Cordillera Valley Club

Design Review Board

Meeting Agenda

Cordillera Valley Club Design Review Board *Staff Memorandum*

1 LOWER LEVEL FLOOR PLAN
1/4" = 1'-0"

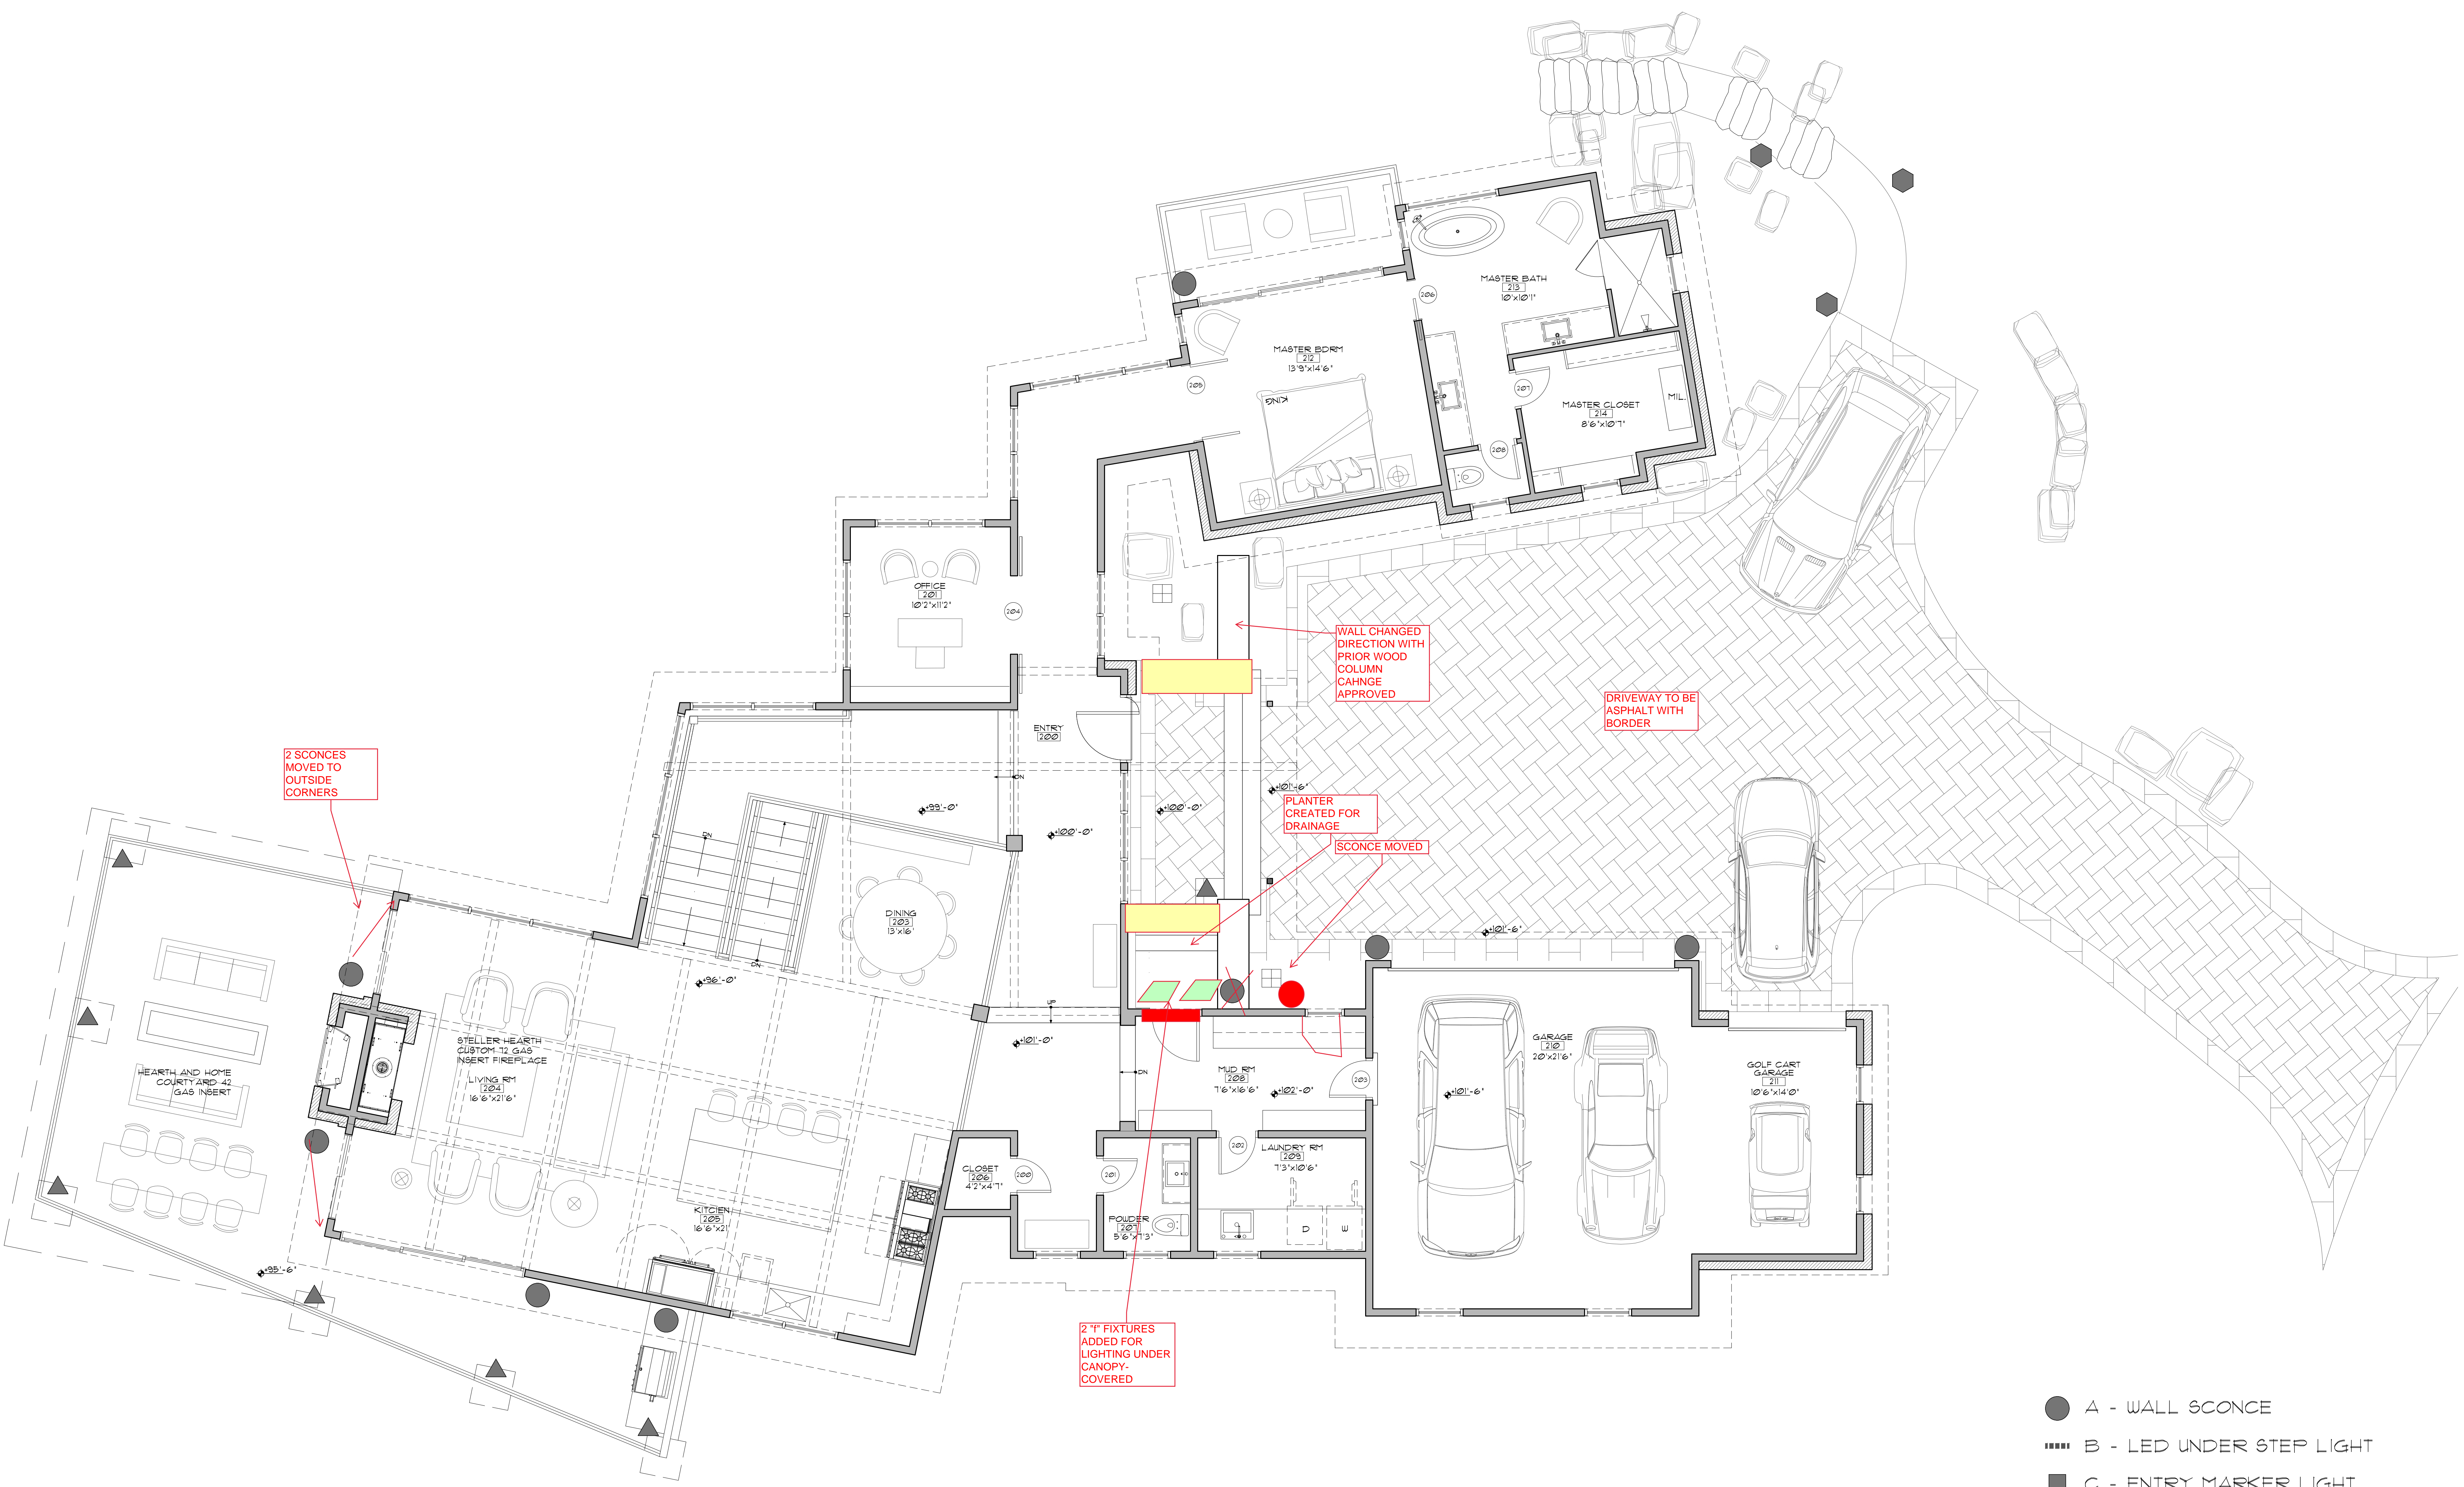
2 SCONCES MOVED TO OUTSIDE CORNERS

WALL CHANGED DIRECTION WITH PRIOR WOOD COLUMN CHANGE APPROVED

DRIVEWAY TO BE ASPHALT WITH BORDER

PLANTER CREATED FOR DRAINAGE
SCONCE MOVED

2 1" FIXTURES ADDED FOR LIGHTING UNDER CANOPY-COVERED
